Concord Middle School Project

Project Manager Report

August 2021

To: Court Booth, Chair CMS Design Subcommittee
 From: Kristen Olsen, SMMA
 Project: Concord Middle School Project
 Re: Design Subcommittee Decisions
 Distribution: (MF)

AUDITORIUM DESIGN
SEATING LAYOUT

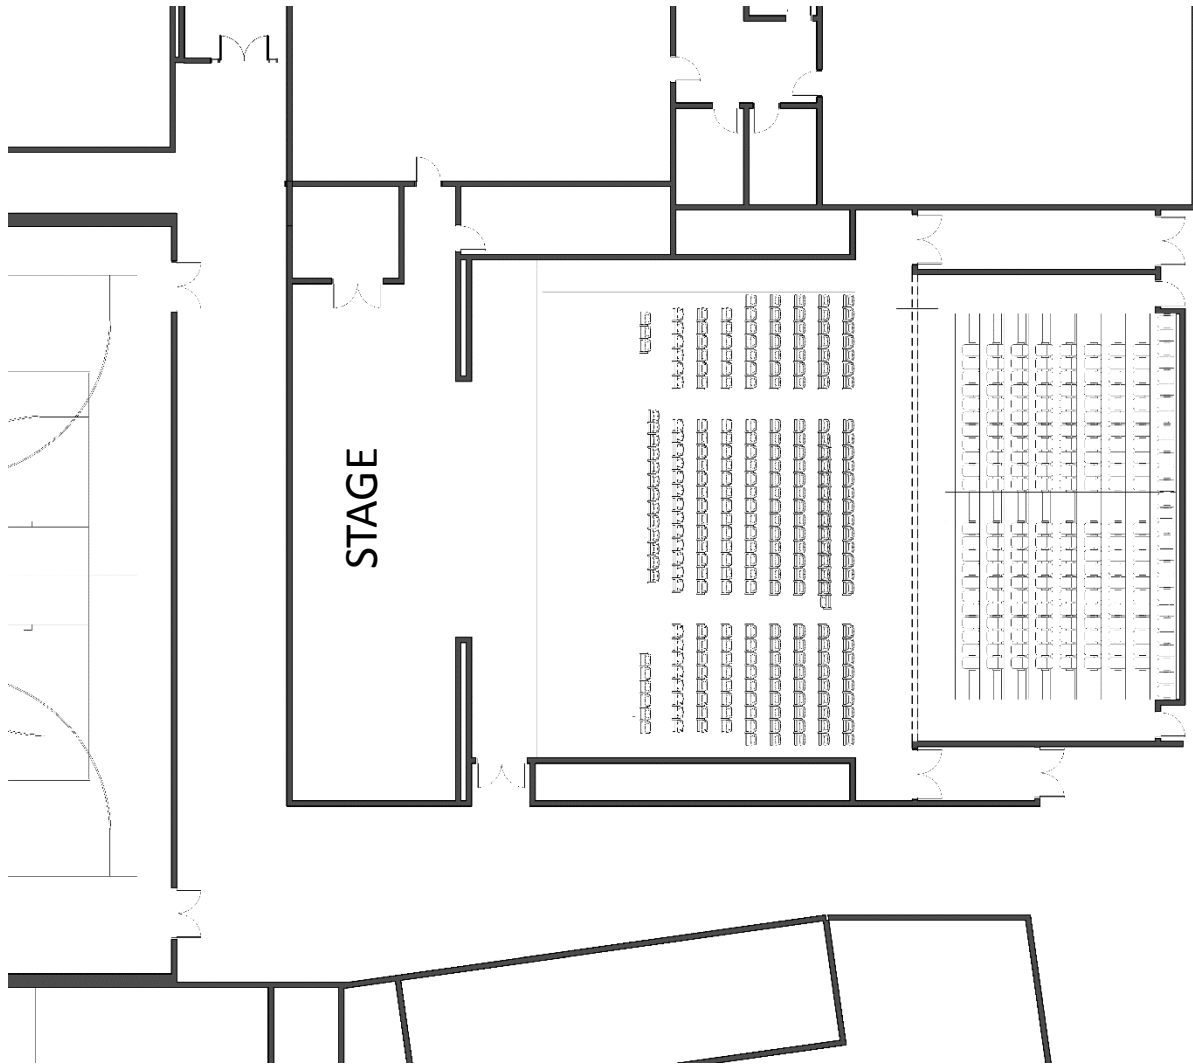
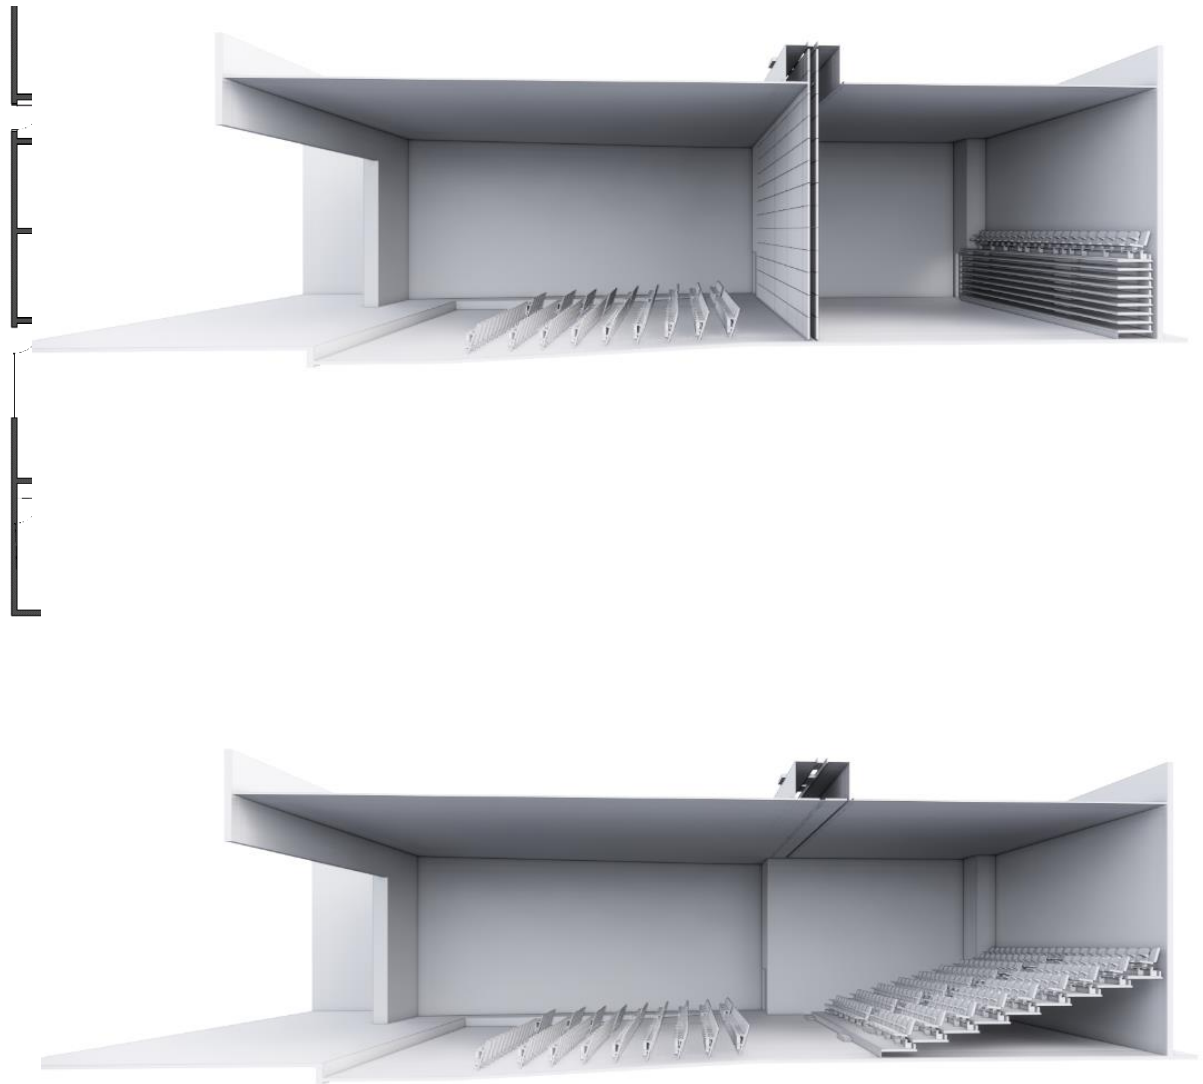
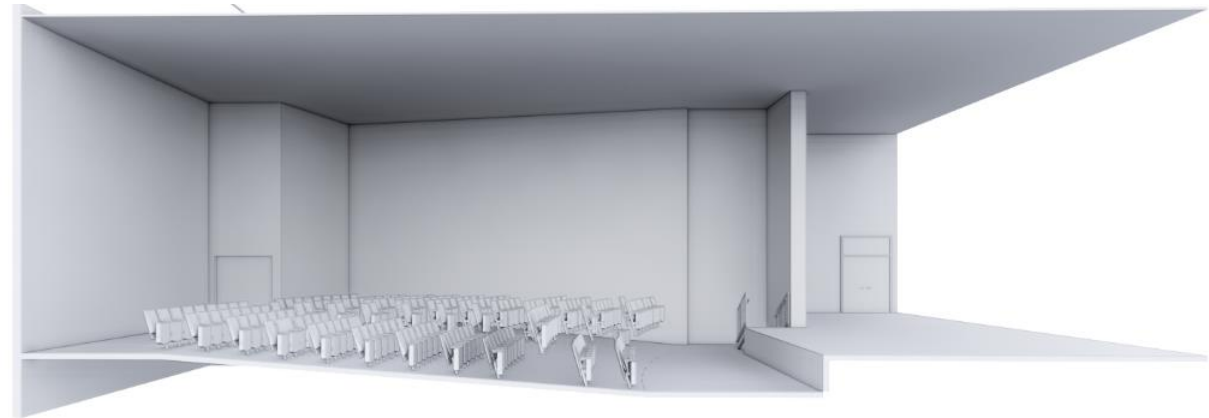
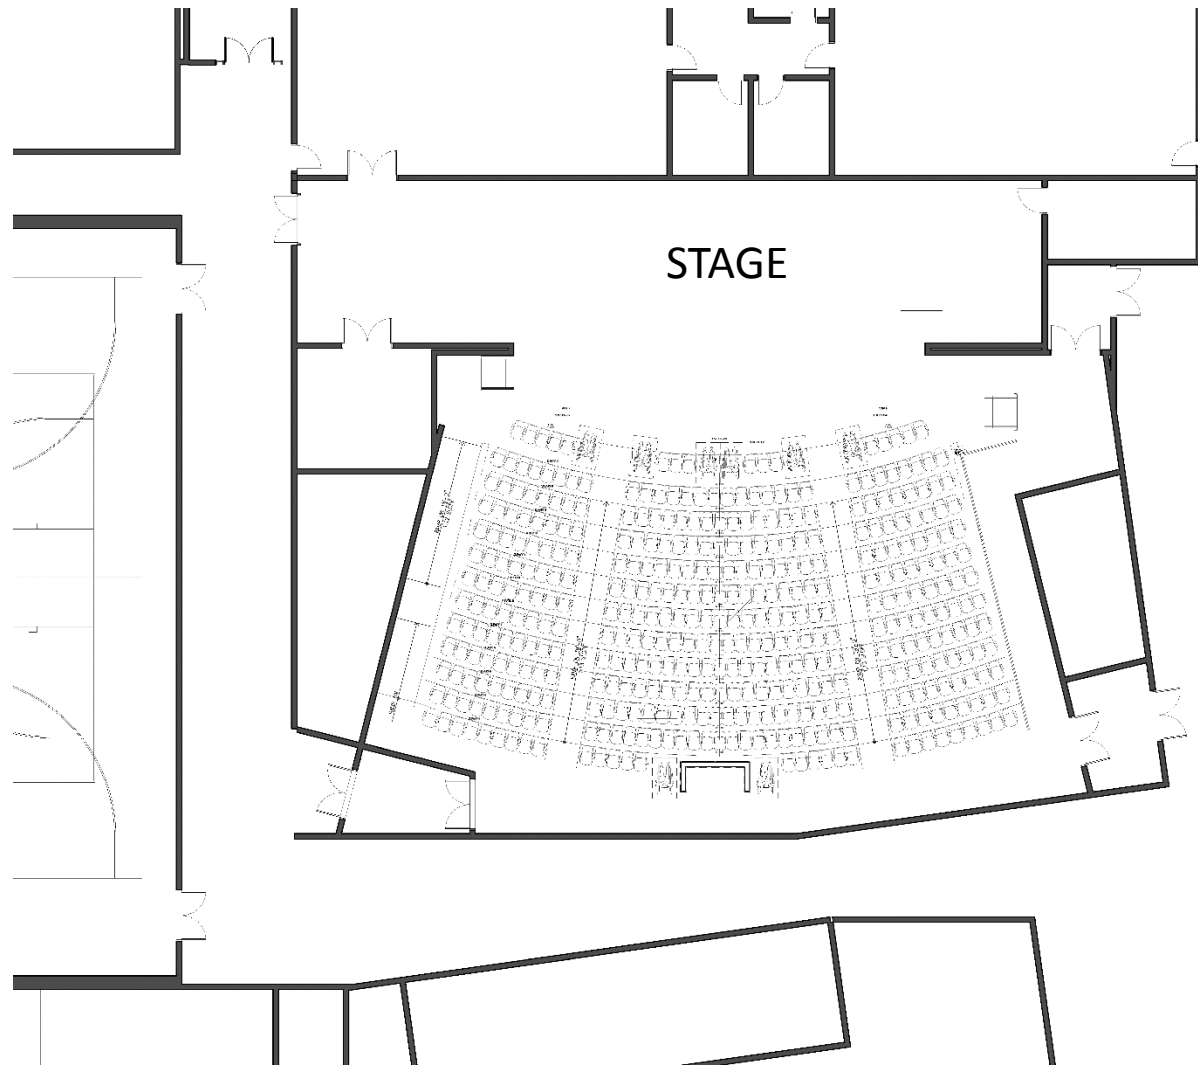
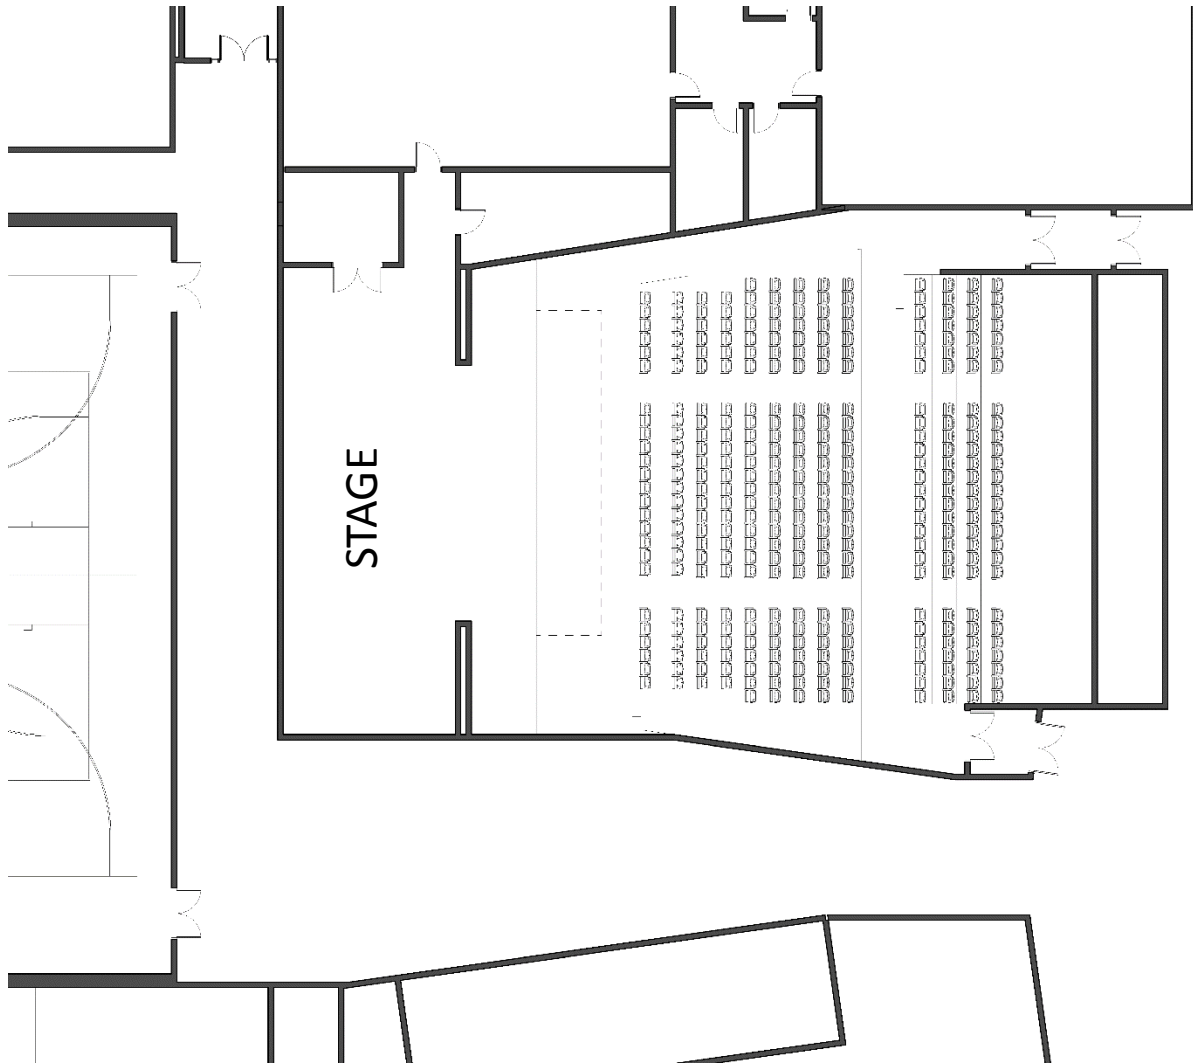
A split-auditorium concept was introduced, recalling the fact that music programming often calls for a flat floor or black box. It would call for a partition to provide for fixed seating for one grade and pull-out seating in the rear; it would provide for another separate music location while narrowing and extending the auditorium configuration. Potential cost adds were not available. The Windsor School in Boston may be a good example of this hybrid approach.

The Subcommittee and the design team examined the new ideas for a hybrid or split auditorium. #1, hybrid, calls for a design with a partition and pull-out seating in the rear room. #2 is the idea most recently adopted by the CMSBC, single room with no partition split, "low sloped floor." #3, sloped and stepped seating, calls for no partition and an elevated rear section. See slide 52. Dr. Hunter conferred with music educators earlier this week and concluded that the hybrid ideas were not strongly favored. The Subcommittee reached consensus that option 2 was still preferred.
